PRODUCT
SUPPORT
BULLETIN # 479

TOOL(S) \ PRODUCT(S) AFFECTED: 2601-20 V18 Compact Driver/Drill

**SUBJECT: 'shut-off' first time tool is heavily loaded - loose screws of 22-56-1230
PCB/Connector Block Assembly**

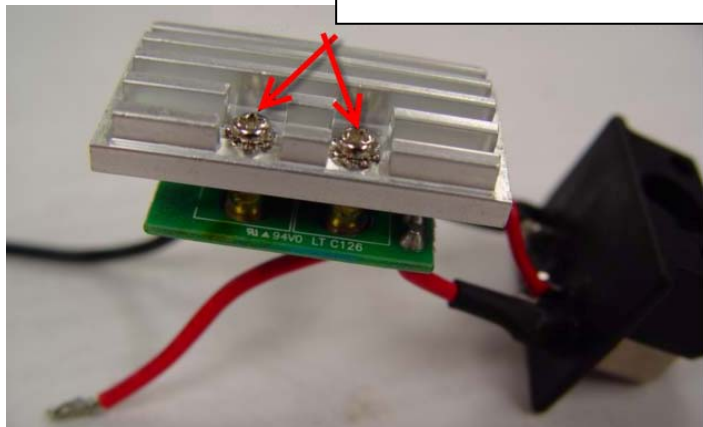
During an early evaluation of the 2601-20 V18 Compact Driver/Drill it was found that a Driver/Drill would "buzz" / "pulse"* and shut off the first time tool was heavily loaded. The heat sink screws on the PBC/Connector block assembly 22-56-1230 were found to be loose causing an intermittent communication between the tool and battery. Additionally, with the communication between the battery and tool to be compromised to a level that the battery remains in a "latched state"^ and will not work on the tool which has loose PBC/Connector block assembly screws until the tool is repaired or the battery is placed on a tool that has a known working PBC/Connector block or a Charger to reset.

check to assure heat sink screws are torqued to specification of 3.5 in/lbs (.395 Nm) for proper working of the PBC/Connector block functions.
